PRAIRIE ISLAND NUCLEAR GENERATING PLANT
Docket Nos. 50-282 License Nos. DPR-42
50-306 DPR-60

Response to Notice of Violation
NRC Inspection Report No. 306/93021(DRP)
Control of Outage Activities

FIGURE 1
SIMPLIFIED FLOW DIAGRAM

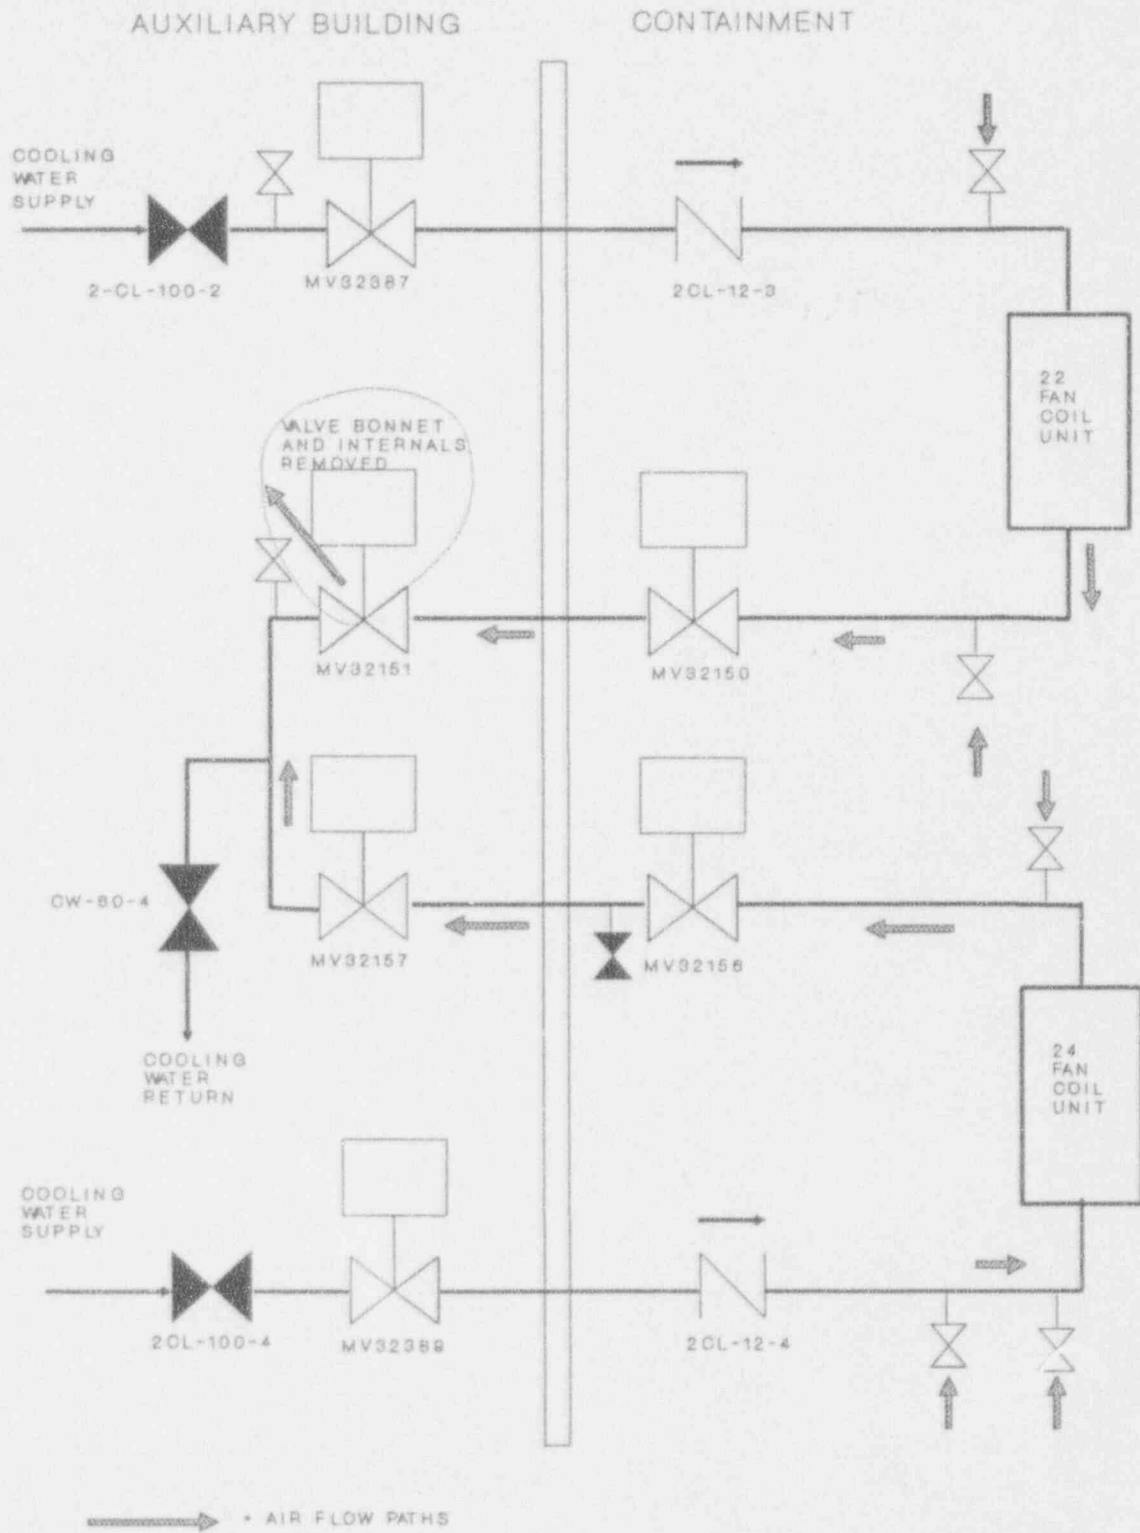
On November 17, 1993, Unit 2 was in cold shutdown for refueling. The Unit 2 core had been unloaded, and maintenance and testing activities were in progress. Work had begun on isolation and repair of MV-32151, No. 22 Fan-Coil Unit Cooling Water Outlet. See Figure 1. The work request required No. 22 and No. 24 Fan-Coil Units (FCU) to be isolated and drained. Cooling water to both FCU's was isolated by closing manual valves 2CL-100-2, 2CL-100-4 and CW-60-4. Motor valves MV-32387, MV-32151, MV-32150, MV-32157, MV-32156 and MV-32389 were opened. Cooling water supply and return line vents and drains were then opened to allow draining of the isolated header.

Contrary to the above, on November 23, 1993, core alterations commenced when a direct path from the containment atmosphere to the outside (in this case the Auxiliary Building) existed through penetration No. 38B because valve MV-32150 was open.

Contrary to the above, on November 17, 1993, an operator installed safety tags on motor-operated valves MV-32387, MV- 32150, and MV-32156, when they were containment boundary components, per work request U2156-ZC-Q, without placing the valves in the required position.

Upon discovery that MV-32150 was open, it was closed manually. MV-32156 was then checked and also found open; it too was closed manually, placing the unit in compliance with Technical Specification 3.8.A.1. MV-32387 was also checked and found open and manually closed.
